# Access Compliance Report

## Public Rights-of-Way

Intersection ID: 28106	Main Street: TOLLIVER_DR	Cross Street: GUNNISON LN	Location: NE
ADA ID: 06C65BD70F08	Ramp Type: PerpDiag	Initial Pass/Fail: Pass	Overall Compliance: No
Severity Score: 20			
Codes/Mitigation Info/Possible Solution		Field Measurements/Component Compliance

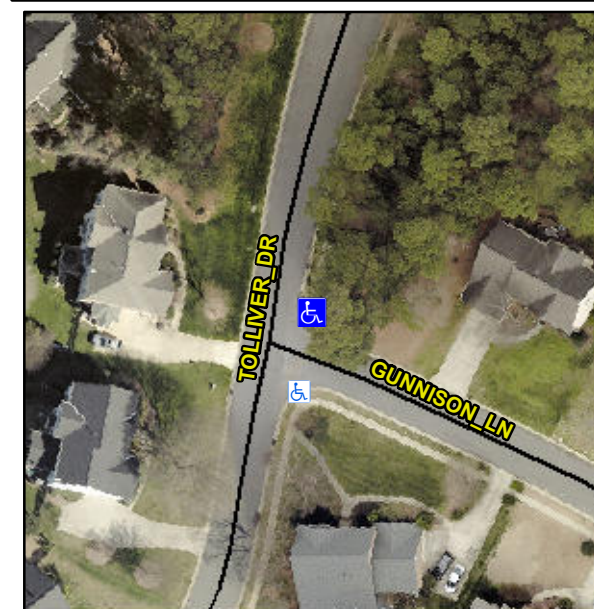
**Not Found, R304.2.1, R304.2.2-Perp, R304.3.2-Para, R304.5.3, R305**

Compliance	Description	Data	Compliance	Description	Data
N/A	Ramp Length (in)	96.0	Yes	Ramp Slope (%)	6.5
Yes	Ramp Width (in)	48.0	Yes	Ramp XSlope (%)	1.4
N/A	Flare Type LT	Sloped	N/A	Flare Type RT	N/A
N/A	Flare Slope LT (%)	2.8	N/A	Flare Slope RT (%)	1.0
N/A	Flare Traversable LT?	No	N/A	Flare Traversable RT?	No
No	Landing Length (in)	N/A	No	DWS Provided?	No
No	Landing Width (in)	N/A	N/A	DWS Contrast?	No
No	Landing Slope (%)	N/A	N/A	DWS Length (in)	N/A
No	Landing X Slope (%)	N/A	N/A	DWS Full Width?	No
N/A	Landing Curb? (Y/N)	No	N/A	DWS Offset (in)	N/A
N/A	Shared Landing?	No			
Yes	Gutter Ponding?	No	Yes	Gutter Slope (%)	4.1
Yes	Gutter Lip Ht (in)	0.0	Yes	Gutter X Slope (%)	1.0
N/A	Painted X Walk1?	No	N/A	Painted X Walk2?	No
	X Walk 1 Direction	To SW		X Walk 2 Direction	To E
N/A	X Walk 1 Width (in)	N/A	N/A	X Walk 2 Width (in)	N/A
	X Walk 1 Slope (%)	1.7		X Walk 2 Slope (%)	1.2
	X Walk 1 X Slope (%)	2.3		X Walk 2 X Slope (%)	1.5

**Remove & Replace Curb Ramp With Two New Directional Ramps or Equivalent.**
